Access Compliance Report

Public Rights-of-Way

Intersection ID: 14249	Main Street: E_3RD_ST	Cross Street: QUEENS_RD	Location: SE
ADA ID: FD4CADFCBE73	Ramp Type: PerpDiag	Initial Pass/Fail: Fail	Overall Compliance: No
Severity Score: 12.5			
Codes/Mitigation Info/Possible Solution		Field Measurements/Component Compliance

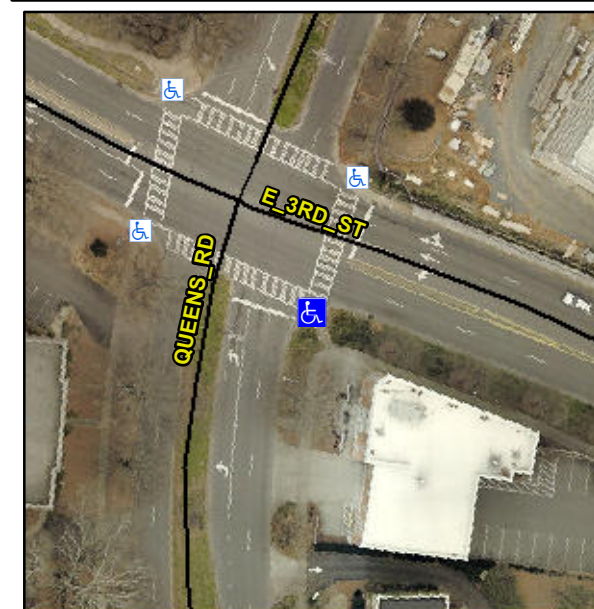
Compliance	Description	Data	Compliance	Description	Data
N/A	Ramp Length (in)	72.5	No	Ramp Slope (%)	10.7
Yes	Ramp Width (in)	49.0	Yes	Ramp XSlope (%)	0.1
N/A	Flare Type LT	N/A	N/A	Flare Type RT	N/A
N/A	Flare Slope LT (%)	N/A	N/A	Flare Slope RT (%)	N/A
N/A	Flare Traversable LT?	N/A	N/A	Flare Traversable RT?	N/A
N/A	Landing Length (in)	N/A	N/A	DWS Provided?	N/A
N/A	Landing Width (in)	N/A	N/A	DWS Contrast?	N/A
N/A	Landing Slope (%)	N/A	N/A	DWS Length (in)	N/A
N/A	Landing X Slope (%)	N/A	N/A	DWS Full Width?	N/A
N/A	Landing Curb? (Y/N)	N/A	N/A	DWS Offset (in)	N/A
N/A	Shared Landing?	N/A			
N/A	Gutter Ponding?	N/A	N/A	Gutter Slope (%)	N/A
N/A	Gutter Lip Ht (in)	N/A	N/A	Gutter X Slope (%)	N/A
N/A	Painted X Walk1?	Yes	N/A	Painted X Walk2?	Yes
	X Walk 1 Direction	To NE		X Walk 2 Direction	To NW
N/A	X Walk 1 Width (in)	114.0	N/A	X Walk 2 Width (in)	113.0
	X Walk 1 Slope (%)	6.3		X Walk 2 Slope (%)	3.1
	X Walk 1 X Slope (%)	1.9		X Walk 2 X Slope (%)	4.2

Remove & Replace Curb Ramp With Two New Directional Ramps or Equivalent.
